## **NUCLEAR REGULATORY COMMISSION**

Title: Advisory Committee on Reactor Safeguards  
SHINE Subcommittee

Date: Tuesday, July 19, 2022

- For SHINE, Figure 7-14 of the TR is modified simply to show the SBM and SVM functionality being performed by the SBVM module (dashed box).

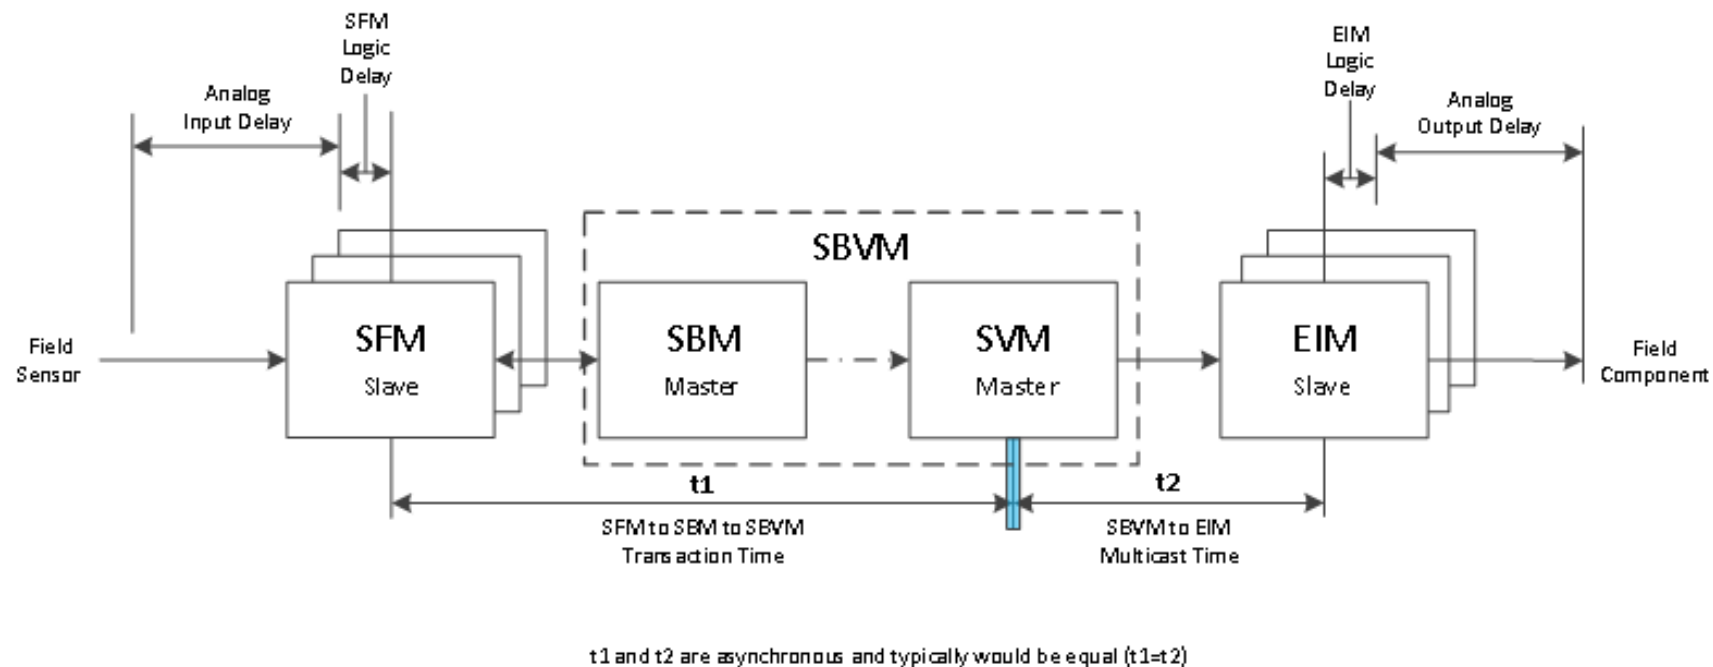
15 Next slide. Just a figure to kind of show  
16 how we have combined the two functions that were  
17 described in the topical report into a single module  
18 of the SBVM.

**Figure 7.1-1 – Instrumentation and Control System Architecture**

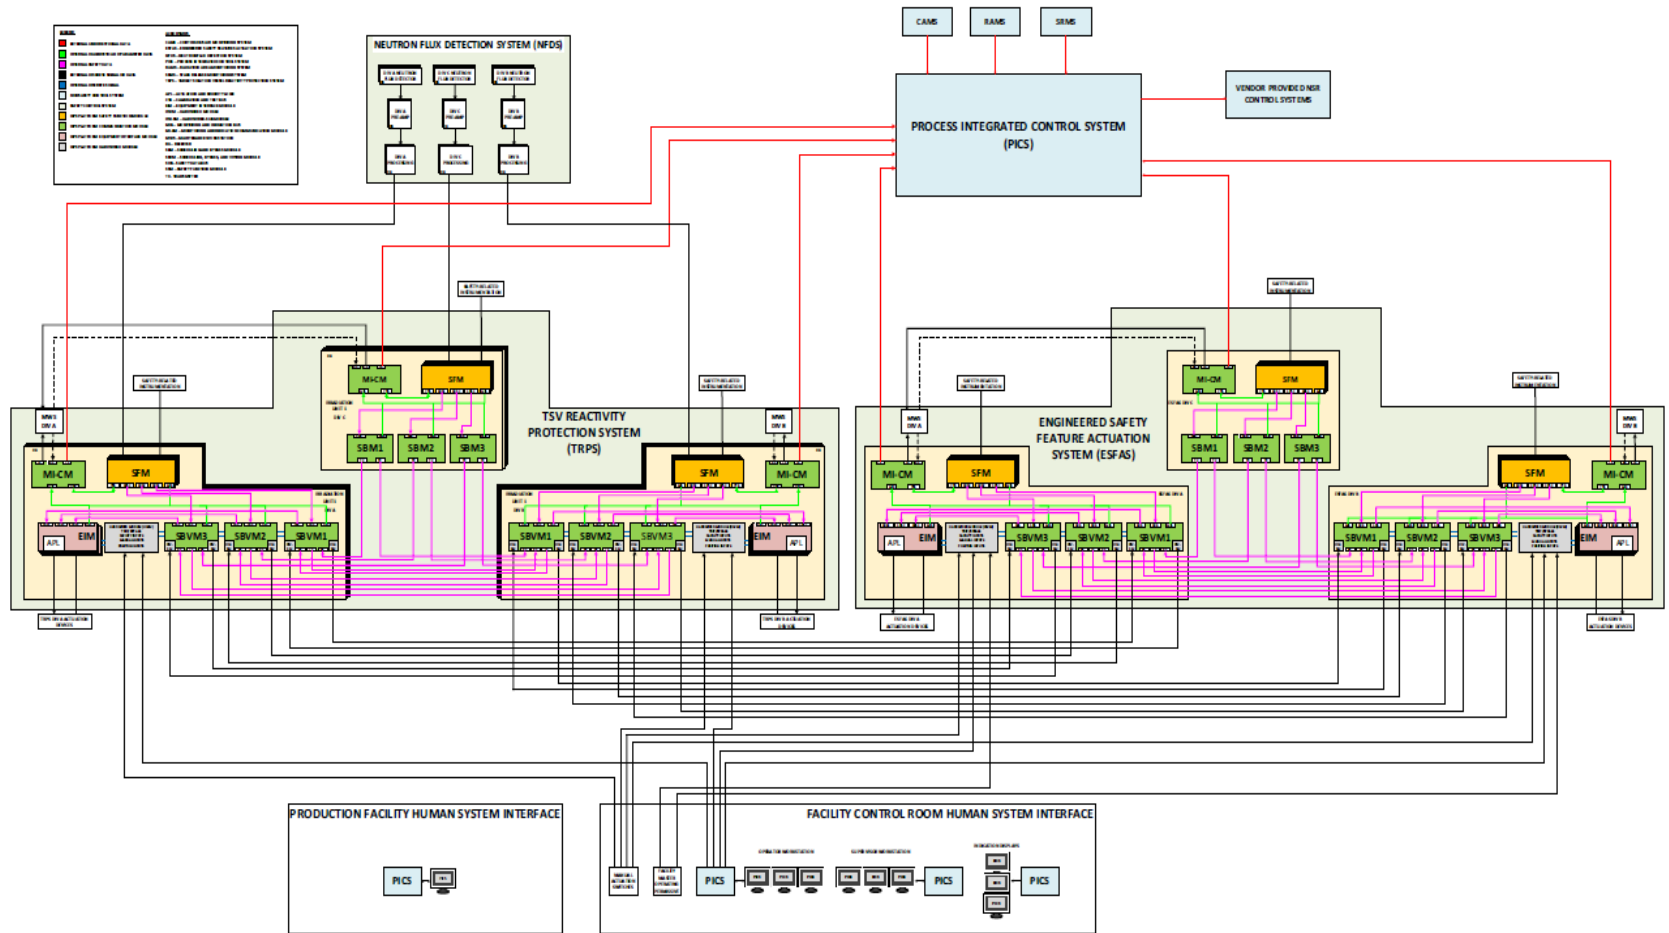
9 The reason I ask the question about the  
10 7.1-1 is that that's the complete picture of how both  
11 the ESFAS and the TRPS connect in and it's not clear  
12 from looking at the picture that that's what you've  
13 got relative to it.

23 That makes it clear and you don't have to  
24 search, word search the text, if you had a note with  
25 that. You did that on the NuScale drawing, by the

1 full details of the design implementation but we do  
2 have that one-way flow of data that starts from each  
3 of the MICMs in each division of the TRPS and the  
4 ESFAS and we're actually aggregating all of those one-  
5 way outputs from the system into a set of redundant  
6 chassis where we aggregate that information up and  
7 then provide it over to the PICS system.
